RE: **Vintage Commerce Center PDA**

RE: DCI2018-10022Vintage Commerce Center CPD
Review 1 Response

This correspondence is our formal response to sufficiency review letter #1, provided to us on December 20, 2018 (via email). Responses to staff comments have been provided in **bold**.

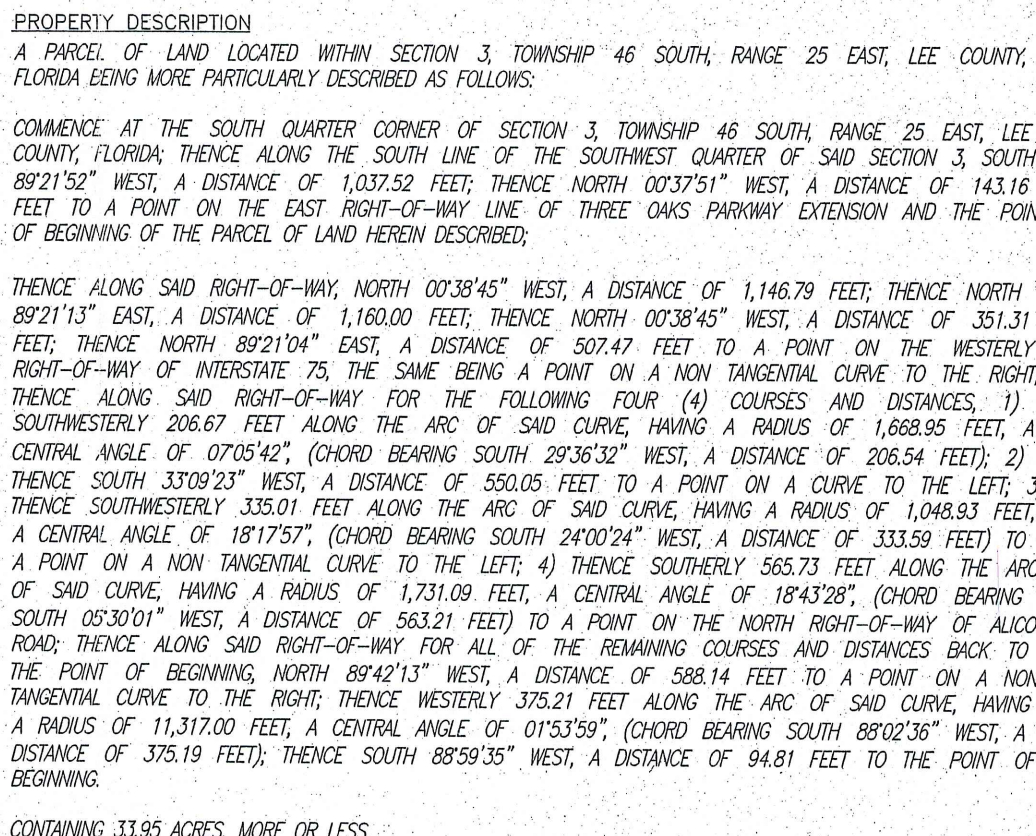
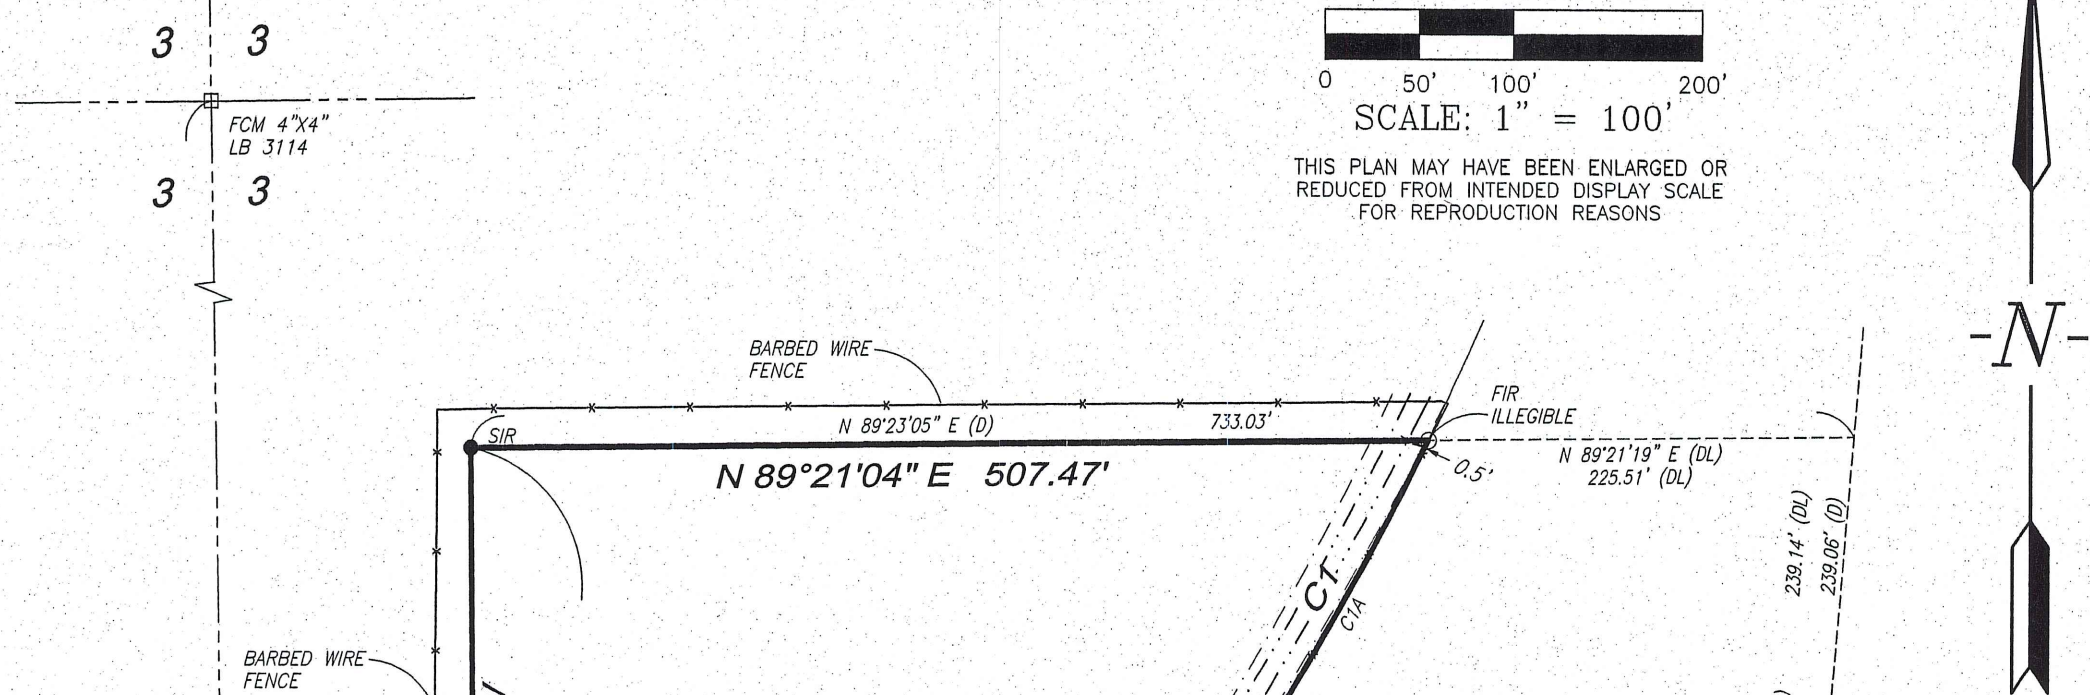
LDC Section 34-202(a)(2) Boundary survey. The boundary survey is based upon a "commitment" for title insurance, rather than an executed title insurance document. The boundary survey must be based upon a title certification document that is sufficient with LDC Section 34-202(A)(3). The boundary survey must be certified to Lee County. It must also provide two state plane coordinate points, one at the point of beginning, and the other at an opposing corner. The legal description on the boundary survey must describe the continuous perimeter of the subject property and must not contain "less and except" language.

The boundary survey has been revised to indicate certification to Lee County.

MASTER CONCEPT PLAN

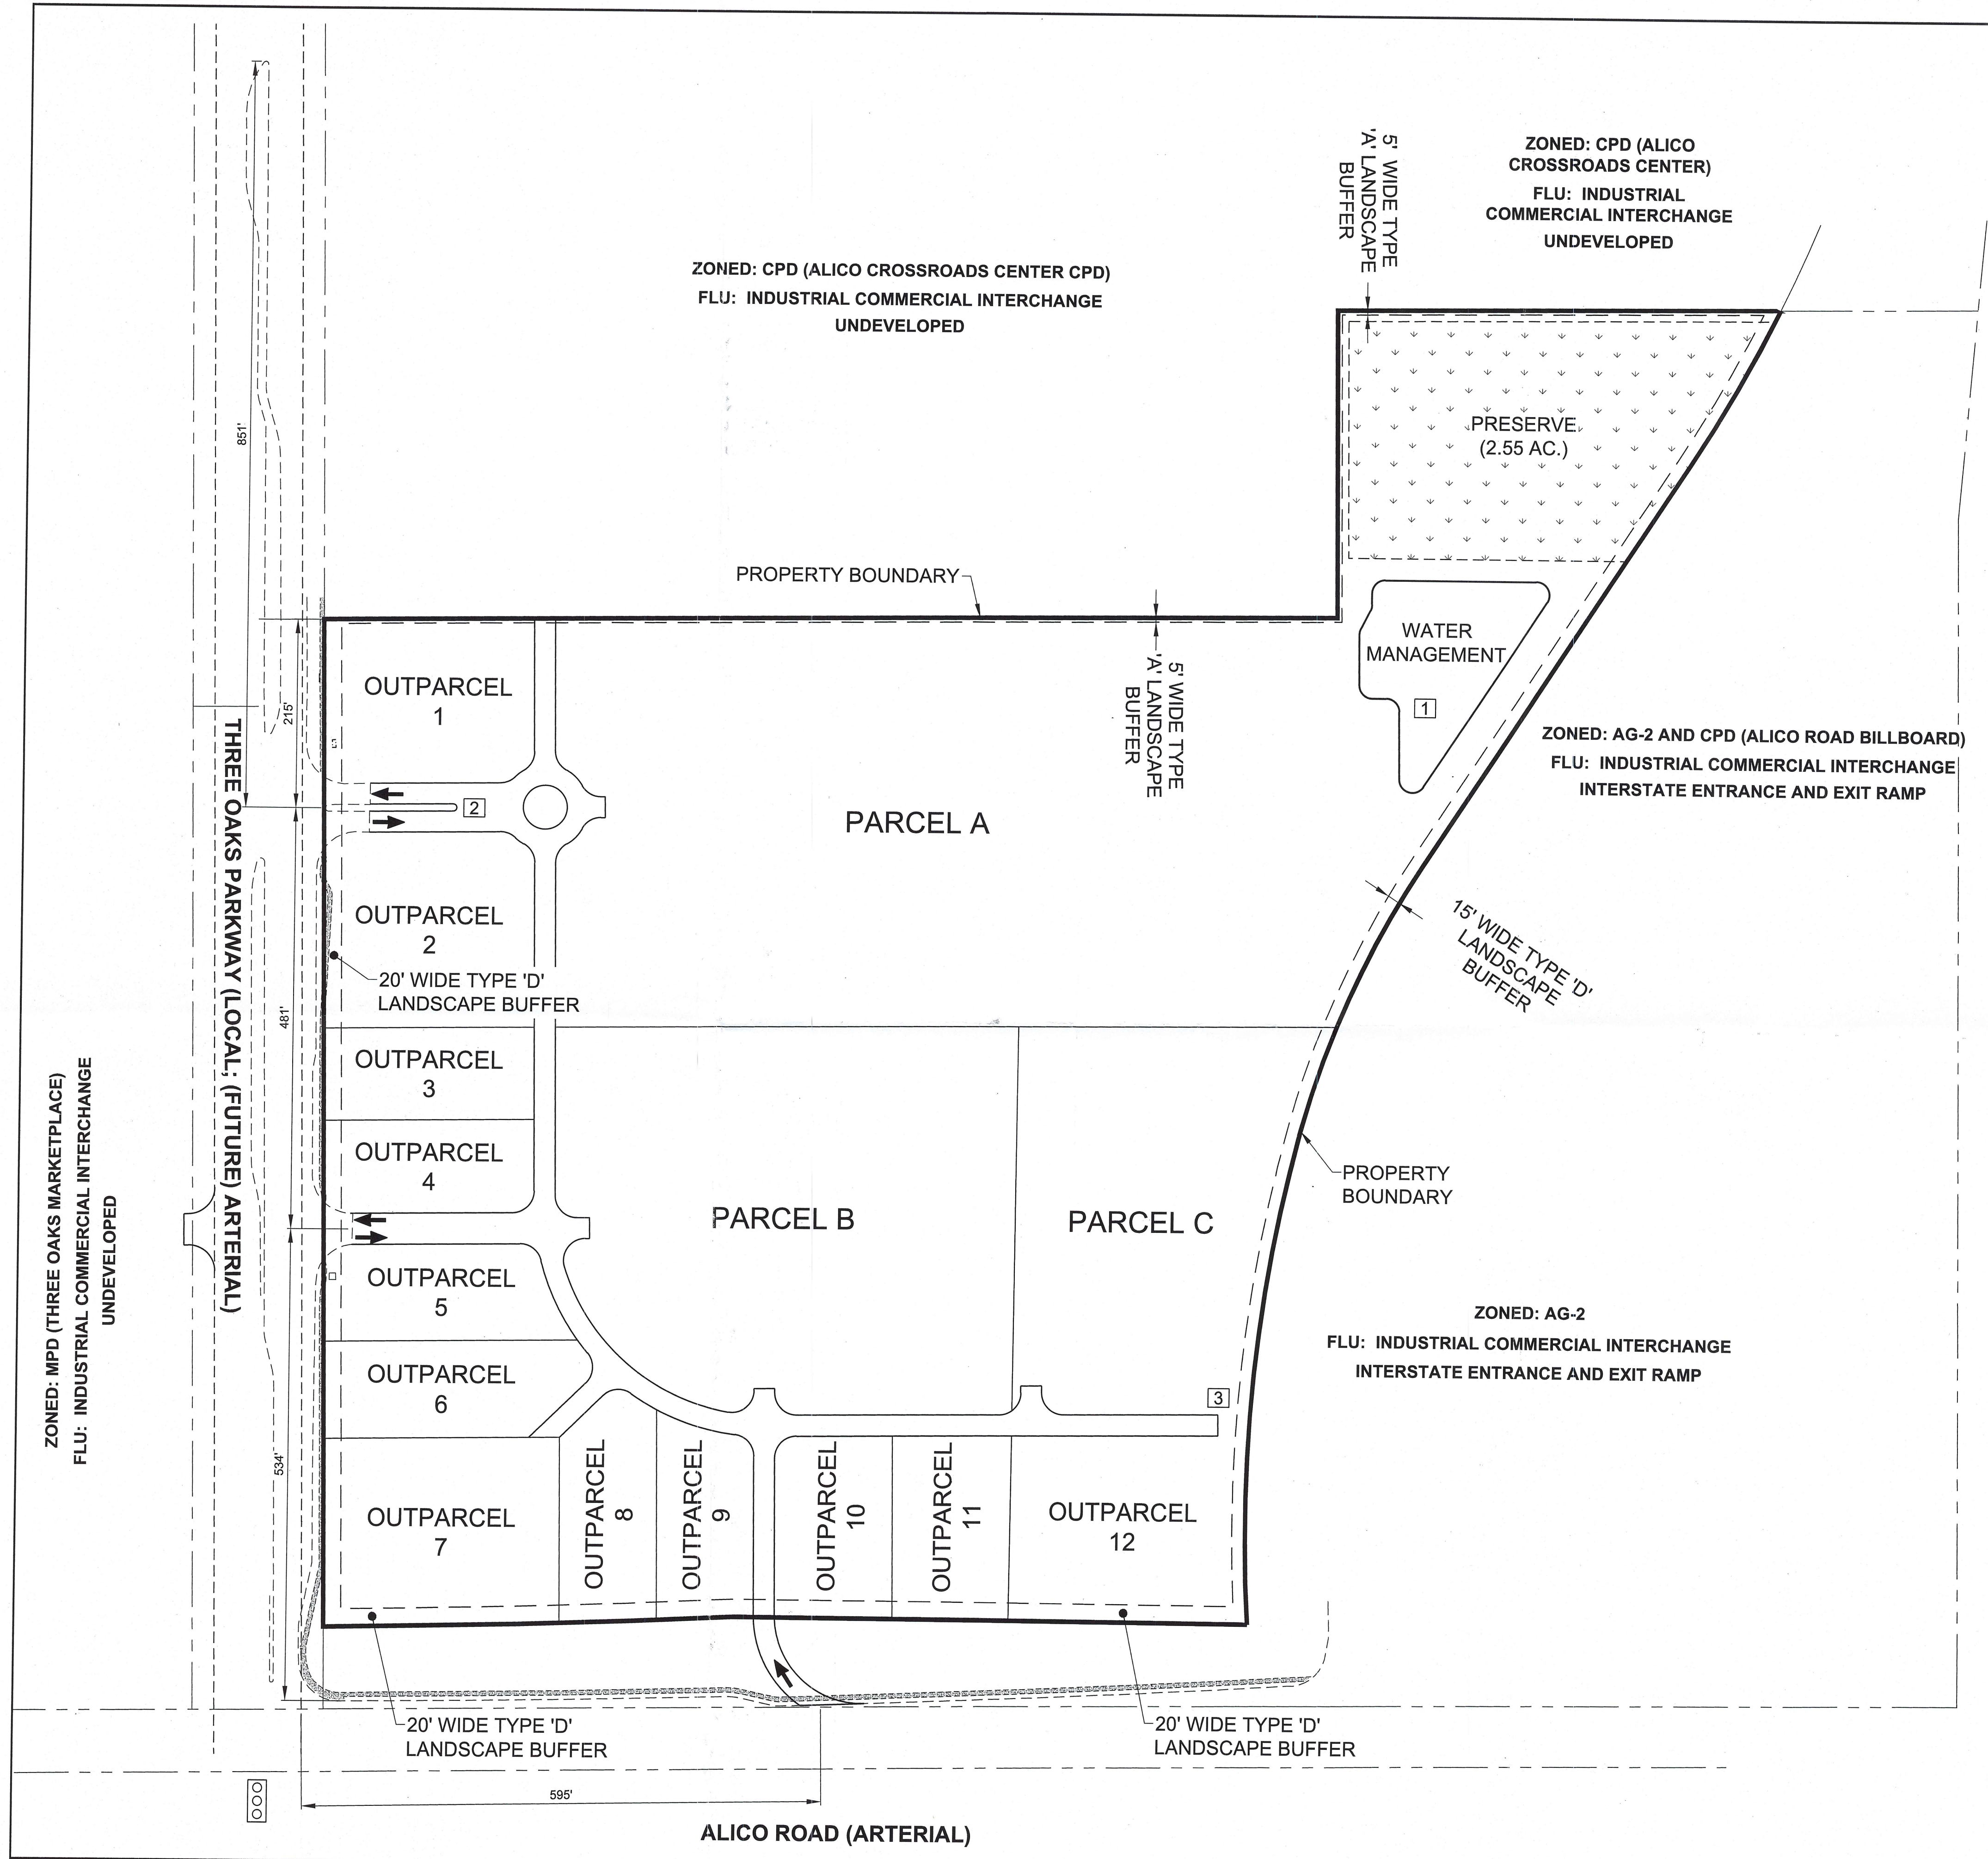
- a. Please revise the MCP to show the location and explanation of all existing easements, whether or not those easements are recorded in accordance with this section. If an easement is based upon a recorded document, the official records book reference must be stated. An example is found in the northwestern corner of the site where the Title Survey shows an access easement.

- b. Please revise the MCP to dimension the ingress and egress locations shown to the adjoining roadways. Also please show the conceptual location(s) for access to each of the proposed parcels. This should be measured edge-to-edge between the project's driveway and the adjacent streets/driveways. Please consider drive and road locations on the opposing side of the street when providing the measurements.

- c. The application provides minimum lot area and dimensions. However, the MCP shows lots and parcels which exceed these minimums. The Property Development Regulations provide for the opportunity in the future to create additional lots or parcels than currently shown on the MCP. Please revise the MCP to indicate the general location, configuration, and approximate dimensions of the lots or parcels (including subdivided parcels and outparcels).

Also, revise the MCP to show proposed use of the lots or parcels keyed to the list of proposed uses submitted with the application. The MCP should also be revised to show what portion of the property is to be rezoned to CPD, and what portion is to be rezoned to RPD.

- d. Please revise the MCP to show the individual development areas (i.e. residential, retail, office, manufacturing, mixed use-listed, etc.) with detail showing the boundary of each development area within which buildings, parking or other uses will be located.

- i. Please make sure the MCP depicts the correct buffer, as required by Code, even between individual uses within the proposed planned development. References to types of buffers as described in Chapter 10 are acceptable.

- j. There is an existing Lee County Transit Route along Alico Road. Please revise the MCP to provide the proposed access and facilities for public transit in accordance with LDC Sections 34-411(e) and 10-442.

- k. Only one location is shown for onsite excavation and wet retention. Please make sure the MCP provides all of the general location of excavations for on-site fill and wet retention. As a reminder, if the applicant proposes to remove excavated material from the property a planned development for mining and a general mining permit may be required.

The master concept plan (MCP) does not appear to show the location of site access points in relation to non-site access points on both sides of the street within proximity of the site. Please review and revise the MCP accordingly.

The master concept plan (MCP) does not appear to identify the roads accessed by the development, including their current functional classification. Please review and revise the MCP accordingly.

Dimensions for ingress/egress locations have been added on the MCP. Turning movement notes have been removed from the MCP.

The MCP has been revised to demonstrate outparcels more consistent with the potential arrangement given the lot area and dimensions.

A notation regarding future compliance with transit requirements as applicable has been added to the MCP.

A notation has been added to the MCP acknowledging that the water management area shown is conceptual and will be developed consistent with the required ERP. It is understood that the precise location will be identified at the time of D.O. approval.

The Master Concept Plan has been revised to show the access points for the property directly to the West of the subject property.

The Master Concept Plan has been revised to identify adjacent roads and functional classification.

FLUCCS	Description	Acreage
262	Fallow Pasture	8.00 ac.
411E1	Pine Flatwoods Invaded by Exotics (10-25%)	21.66 ac.
510D	Ditches	1.50 ac.
740	Disturbed Land	0.14 ac.
743	Spoil Areas	2.65 ac.
Total		33.95 ac.

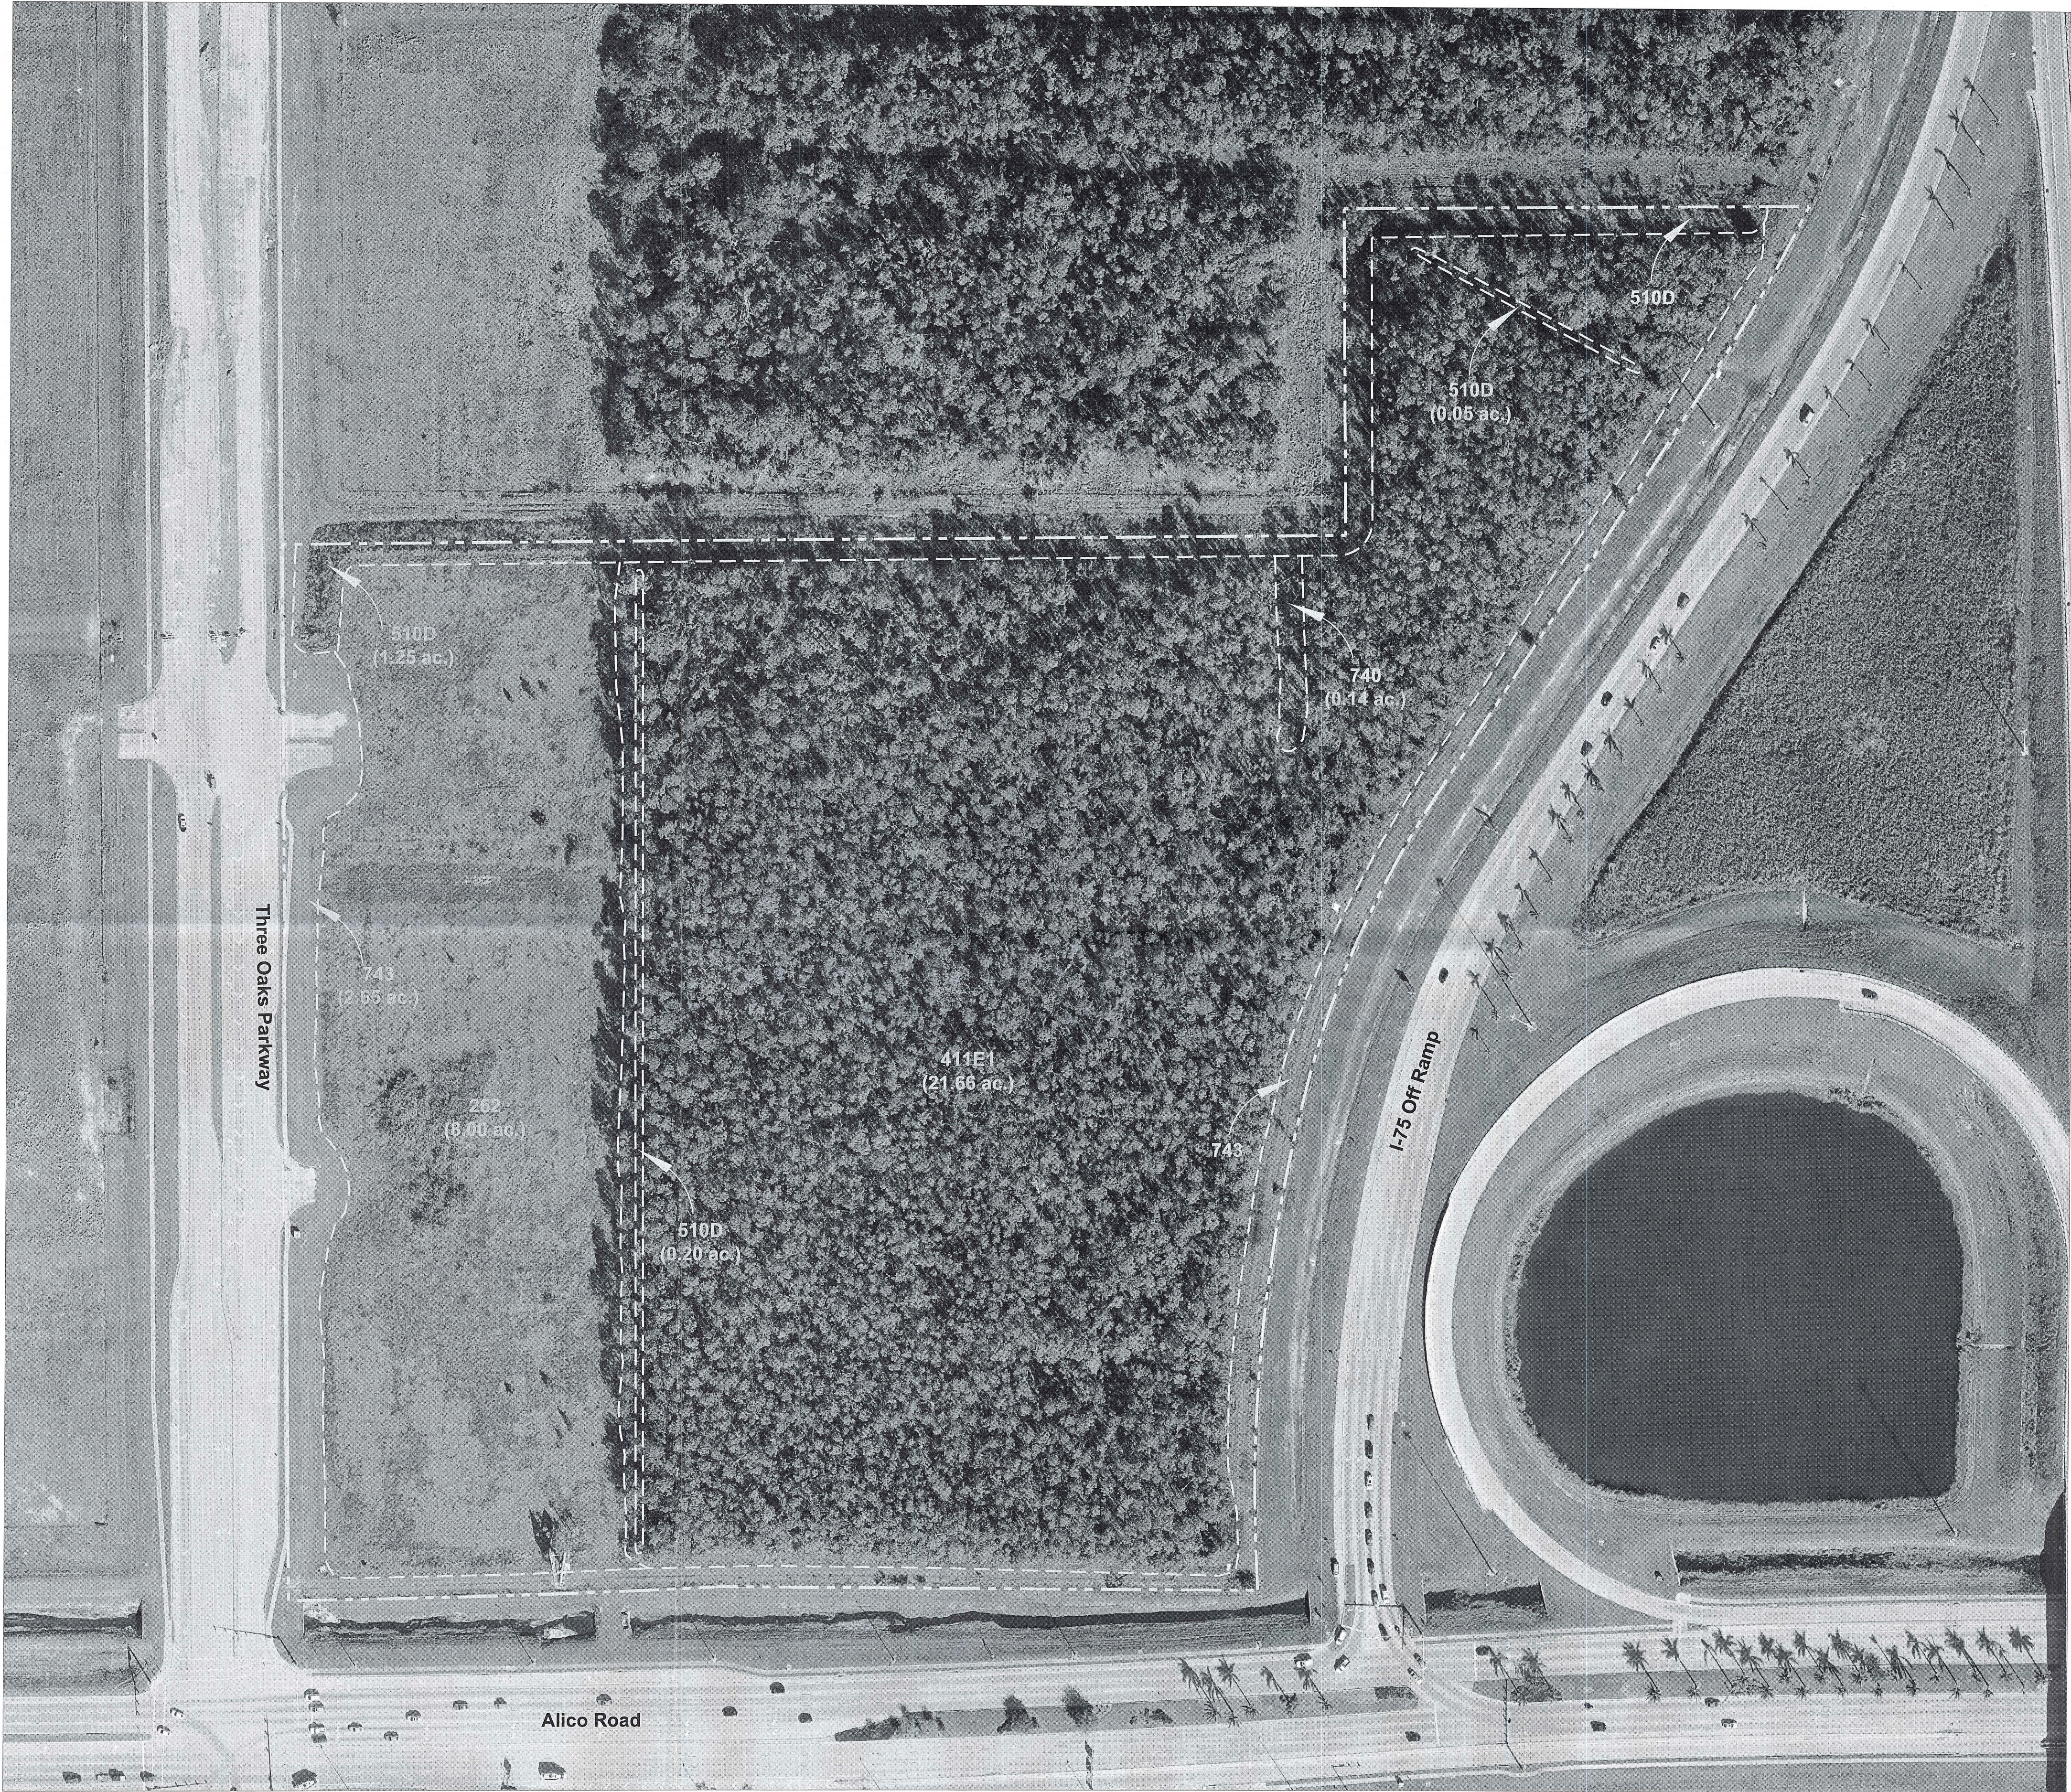
Please provide the Florida Land Use, Cover and Classification System (FLUCCS) map, as required by this Section.
